**Identification cards — Contactless
integrated circuit cards — Proximity
cards —**

**Part 3:
Initialization and anticollision**

**AMENDMENT 1: Electromagnetic
disturbance handling and single-size unique
identifier**

Amendment 1 to ISO/IEC 14443-3:2011 was prepared by Joint Technical Committee ISO/IEC JTC 1, *Information technology*, Subcommittee SC 17, *Cards and personal identification*.

Figure 1 — Frame delay time PCD to PICC

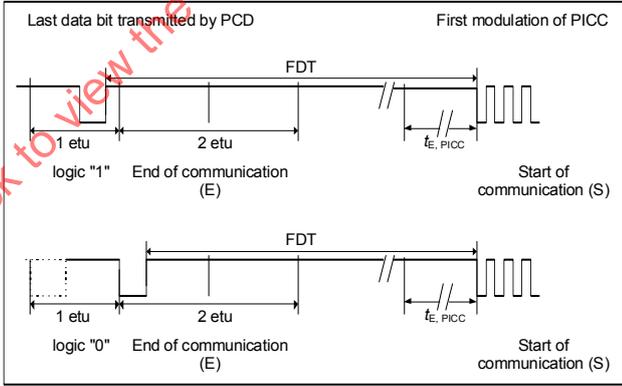
Page 7, 6.2.1.1

Replace Figure 1 with the following:

NOTE $t_{E,PICC}$ is specified in Clause 8.

Figure 17 — Timing before the PICC SOF

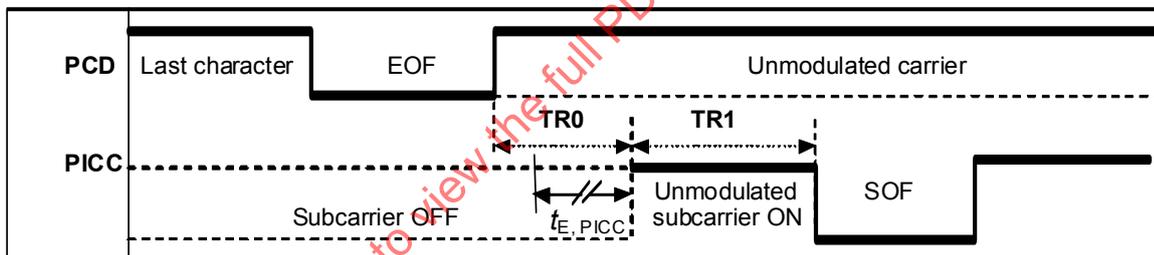
Replace Figure 17 with the following:

NOTE $t_{E,PICC}$ is specified in Clause 8.

Figure 33 — Low EMD time

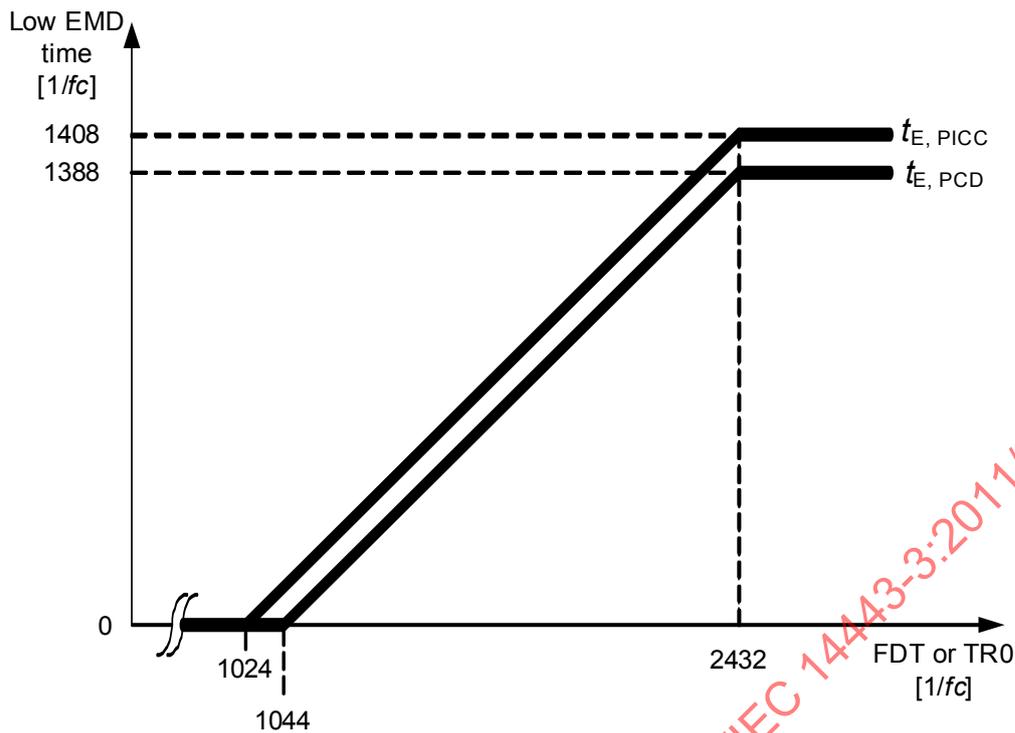
The low EMD time for PCD and PICC are illustrated in Figure 33.

The low EMD time $t_{E,PICC}$ is the time period before the start of PICC data transmission, when the PICC shall not produce an EMD level higher than the EMD limit as defined in ISO/IEC 14443-2/Amd.1.

This low EMD time $t_{E,PICC}$ has a value of $F - 1024/fc$ with a maximum value of $1408/fc$ where F equals FDT for Type A and TR0 for Type B. The value is $0/fc$ for $TR0 \leq 1024/fc$.

The low EMD time $t_{E,PCD}$ is the time period to allow the PCD to recover from electromagnetic disturbances.

The PCD shall be ready to process a PICC frame no later than $t_{E,PCD}$ after the last time the EMD level was above the EMD limit as defined in ISO/IEC 14443-2/Amd.1.

This low EMD time $t_{E,PCD}$ has a value of $F - 1044/fc$ with a maximum value of $1388/fc$ where F equals FDT for Type A and TR0 for Type B. The value is $0/fc$ for $TR0 \leq 1044/fc$.
